ADDENDA

THE RDF-10 RADIO DIRECTION FINDER

The following corrections and changes should be applied to the current issue of the RDF-10 Radio Direction Finder Instruction Manual.

9. Plot the 36 readings taken on the deviation chart, figure 5.

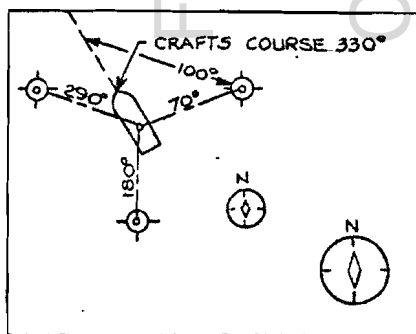
1. Page 7, Calibration, Item 9 should be as follows:

For example the readings may appear as follows:

The curve for these example readings are shown as a dotted line on the deviation chart.

<u>PELORUS</u>	<u>RDF BEARING</u>	<u>DEVIATION CORRECTIONS</u>
0°	0	
10°	7 1/2	+2 1/2
20°	16	+4
30°	25 1/2	+4 1/2
40°	35	+5
50°	45	+5
60°	55 1/2	+4 1/2
70°	66	+4
80°	77 1/2	+2 1/2
90°	90	0
100°	102 1/2	-2 1/2
110°	114	-4
120°	124 1/2	-4 1/2
130°	135	-5
